UNITED STATES PATENT AND TRADEMARK OFFICE

APPLICATION NO.	FILING DATE	FIRST NAMED INVENTOR	ATTORNEY DOCKET NO.	CONFIRMATION NO.
10/658,302	09/09/2003	William Shelmon	TTC-13002/08	2137
25006	7590	06/07/2006	EXAMINER	
GIFFORD, KRASS, GROH, SPRINKLE & CITKOWSKI, P.C PO BOX 7021 TROY, MI 48007-7021			LARSON, JUSTIN MATTHEW	
			ART UNIT	PAPER NUMBER
			3727

Office Action Summary	Application No. 10/658,302	Applicant(s) SHELMON ET AL.	
	Examiner Justin M. Larson	Art Unit 3727

DETAILED ACTION

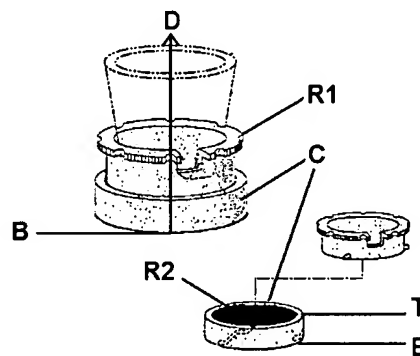
Regarding the newly added limitations to claims 1, 6, and 10, Examiner provides the following Figure and explanations:

Regarding the limitation "said at least one recessed portion extending between a top end and an opposite bottom end of said carrier portion", in the above figure, the recessed portion (R2) of Dennis et al. clearly extends between a top end (T) and a bottom end (B) of the carrier portion (C).

Regarding the limitation "said receptor portion protruding axially outwardly relative to said bottom end while in said extended position", in the above figure, the

receptor portion (R1) of Dennis et al. clearly extends in a direction (D) out of the carrier portion (C), the direction being upward and outward from the carrier (C) relative to the bottom (B) of the carrier (C).

FIG. 7

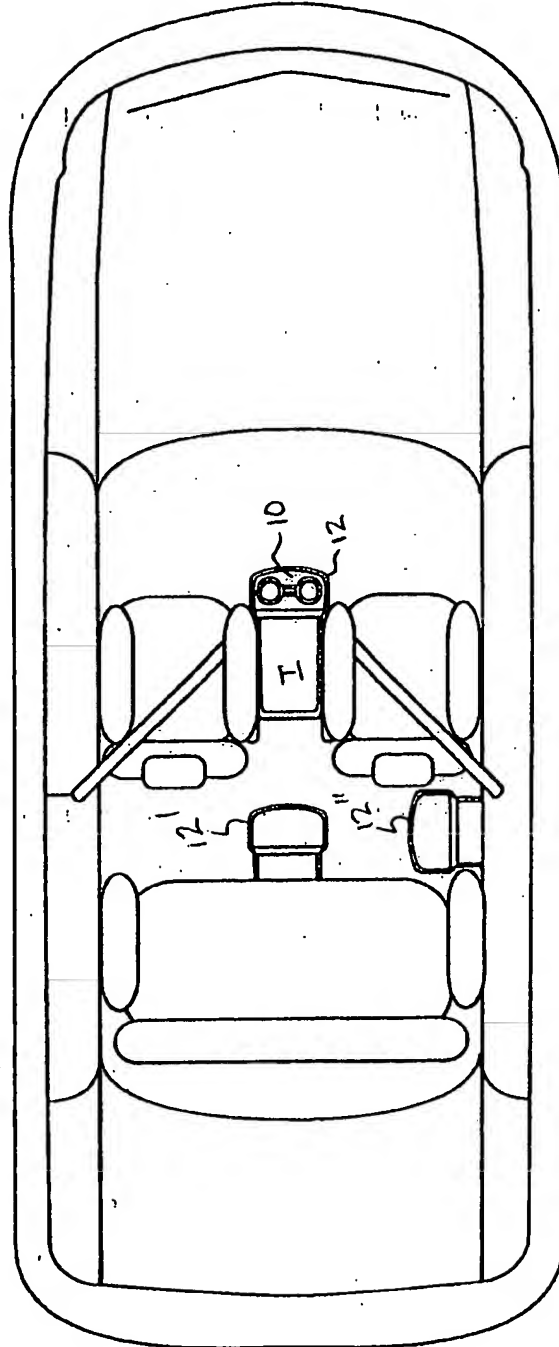
1. The drawings were received on 3/2/06. These drawings are not approved because Figure 7 contains New Matter. Figure 7 shows specific locations of the container holder within the vehicle that were not specifically mentioned in the originally filed disclosure.

NOT APPROVED JML 5/30/06
